UNITED STATES PATENT AND TRADEMARK OFFICE

APPLICATION NO.	FILING DATE	FIRST NAMED INVENTOR	ATTORNEY DOCKET NO.	CONFIRMATION NO.
10/648,876	08/27/2003	Frank Reineke	J010-3478	4890

Office Action Summary	Application No. 10/648,876	Applicant(s) REINEKE, FRANK	
	Examiner Gregory J. Strimbu	Art Unit 3634

FIG. 4

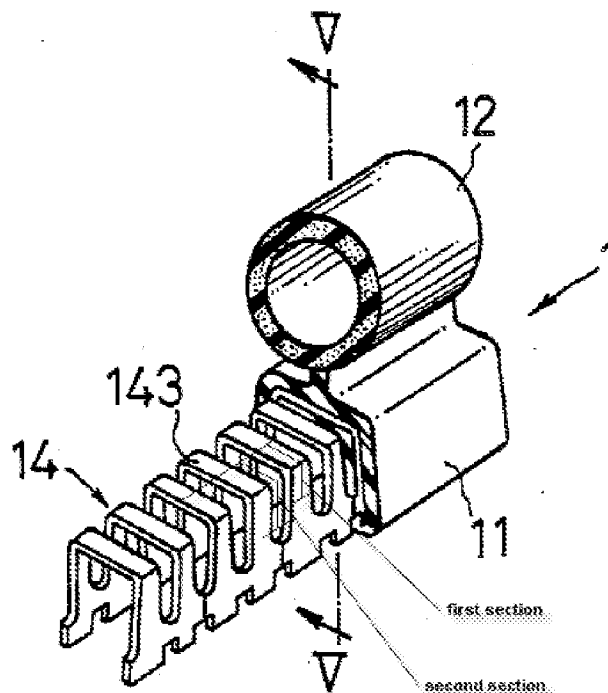
Regarding the applicant's comments concerning Shigeki et al., the examiner respectfully disagrees. As illustrated below, the claim limitation "sections" can mean

any part of the core member 14 and its extruded covering. Thus, the "sections" are discontinuous and can vary in length depending upon how one chooses to define a "section". The applicant's comments concerning Shigeki et al. failing to disclose two different materials whereby one material is continuously interrupted by pieces of the other material are not persuasive because they are not supported by the claim language.
